Addendum ADD#3

Date: June 10, 2026
Project Name: Verona Housing
Project Address: 6094 Carleton Dr, Verona, ON K0H 0B8
Project Number: 26001

Structural Addendum #2

KEY NOTES:

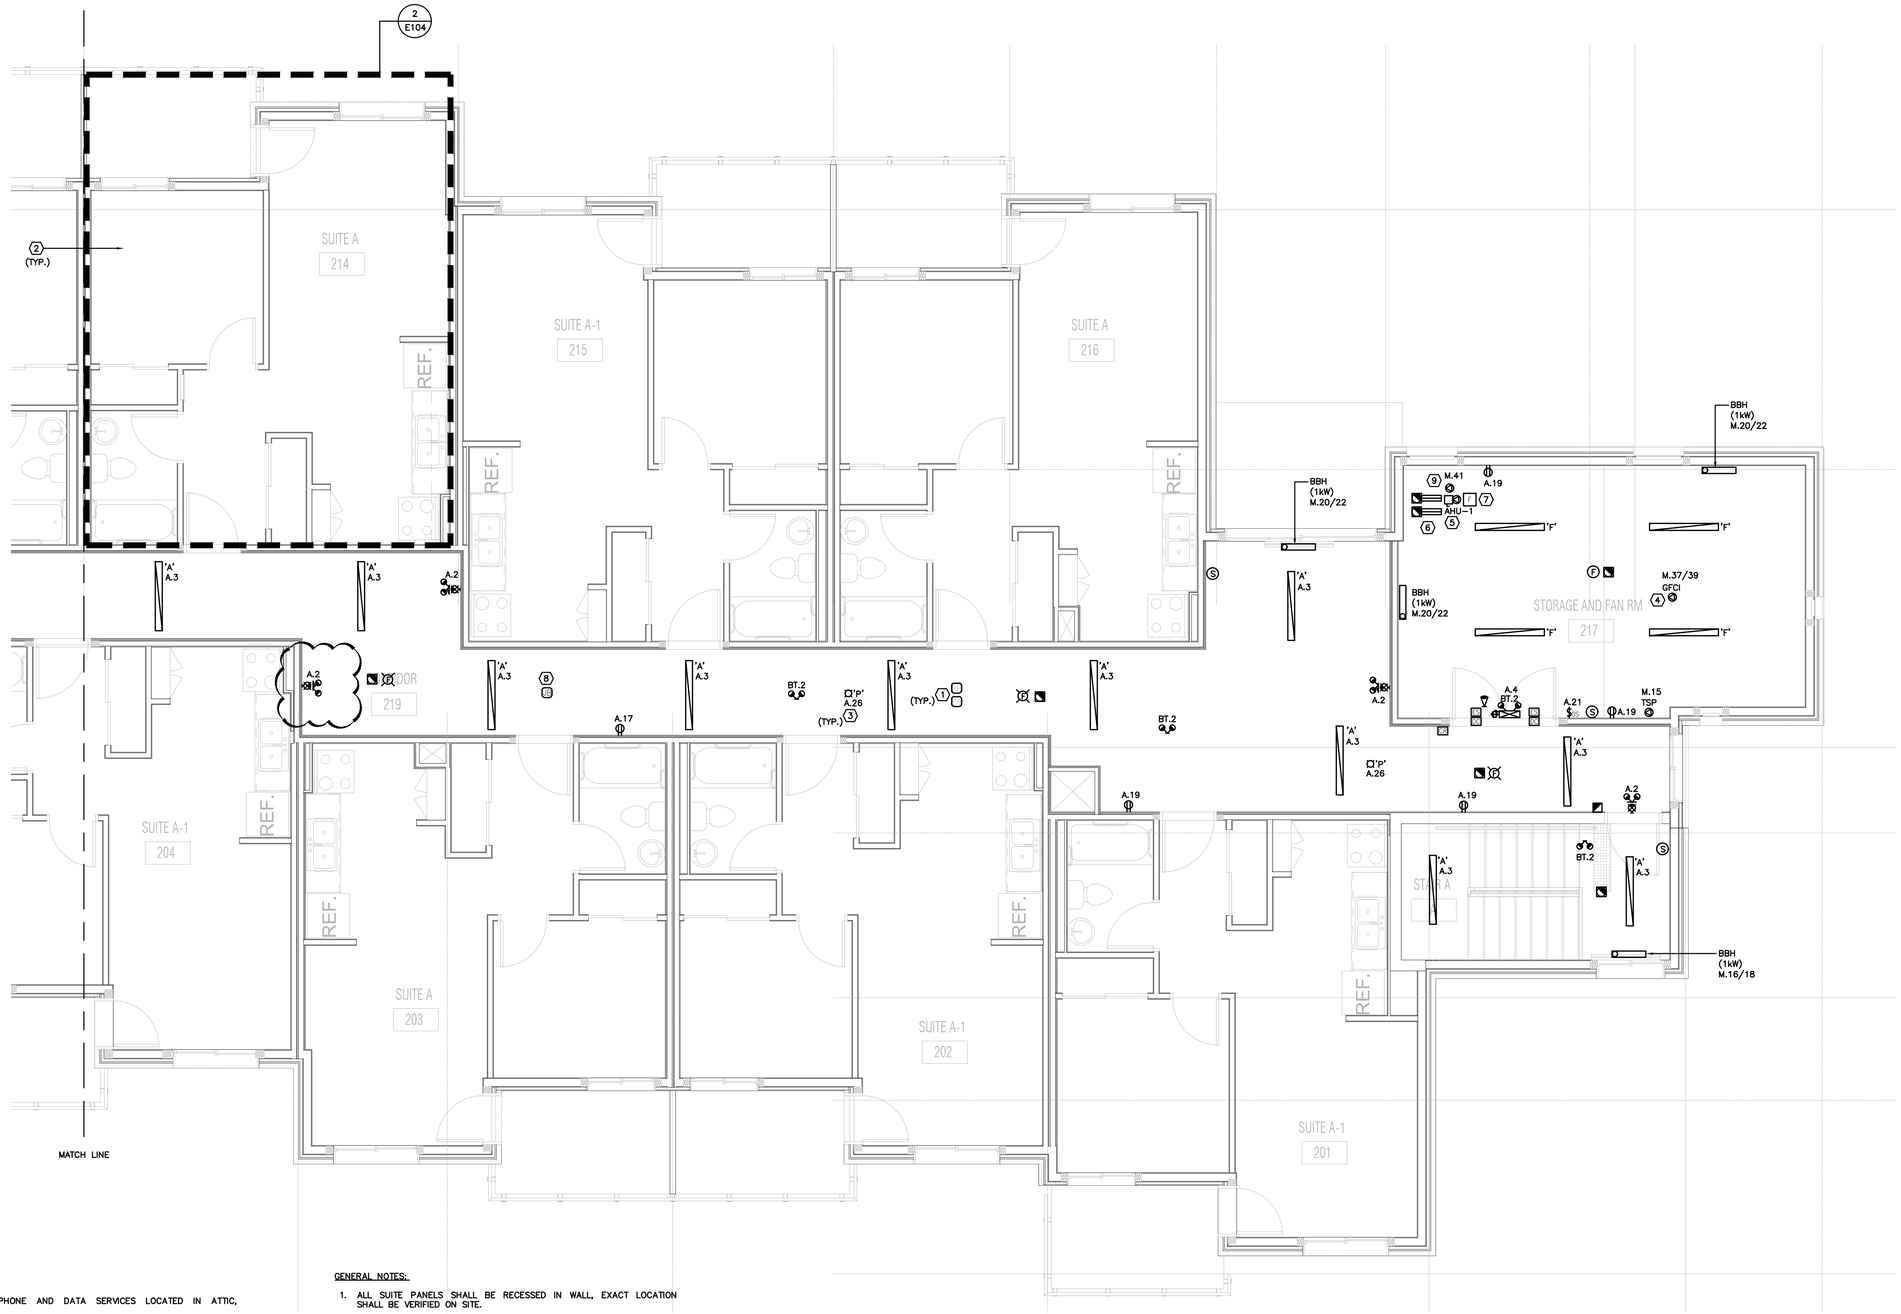
2. **Drawing E101A - E102B (Re Issued)**
   2.1. Revise the emergency lighting and exit signs as indicated.
   2.2. Provide new auto door systems as indicated.

1 E104 DISTRIBUTION DIAGRAM
SCALE: N.T.S.

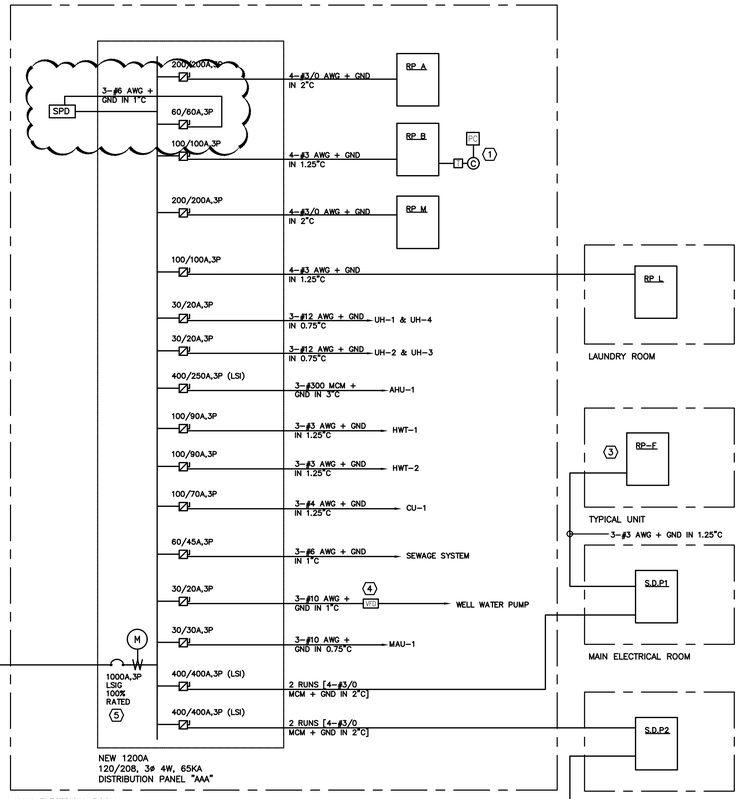
3. **Drawing E104 (Re Issued)**
   3.1. Revise the single line diagram as indicated.
   3.2. Revise panel schedules as indicated.
